HySecurity Inc. 6623 South 228th St. Kent Wa. 98032-1876

MOTOR RELAY BY-PASS

ECN NO:
D0018

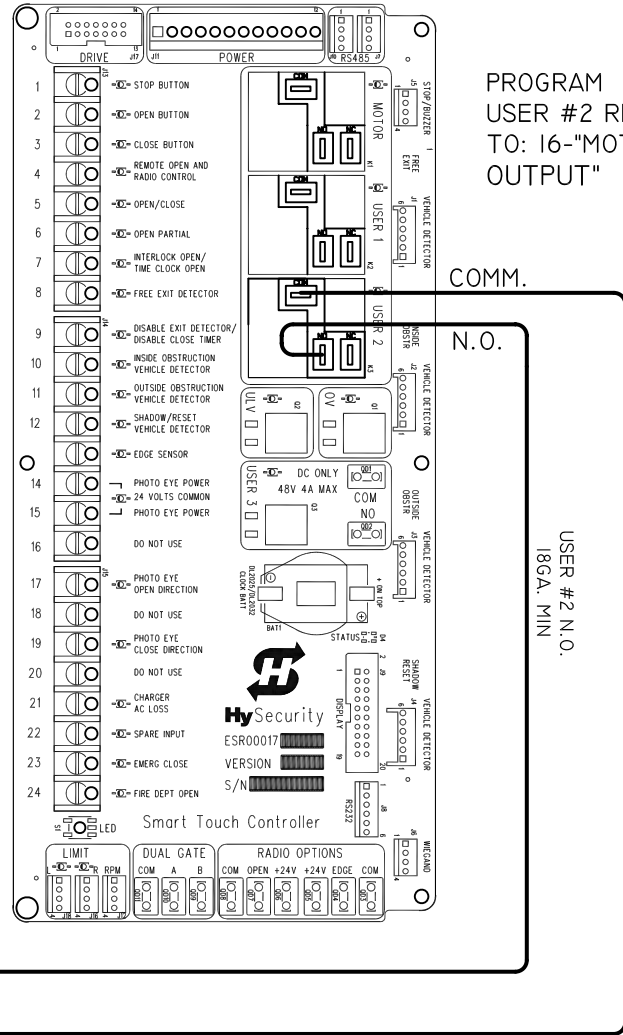
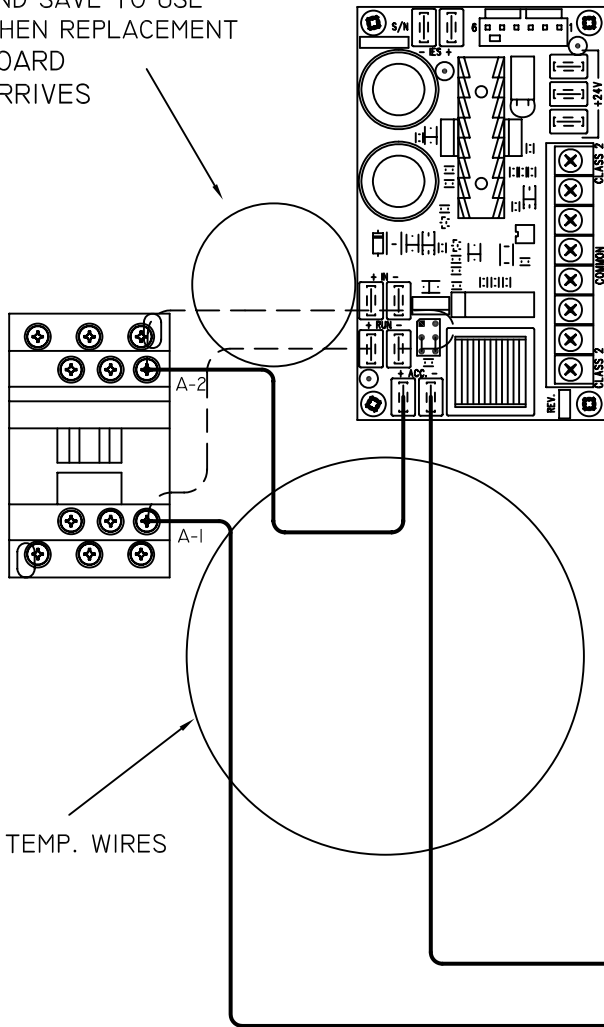
REMOVE THESE WIRES FROM THE CONTACTOR TO THE POWER SUPPLY
AND SAVE TO USE
WHEN REPLACEMENT
BOARD
ARRIVES

PROGRAM
USER #2 RELAY
TO: 16-"MOTOR RUNNING
OUTPUT"
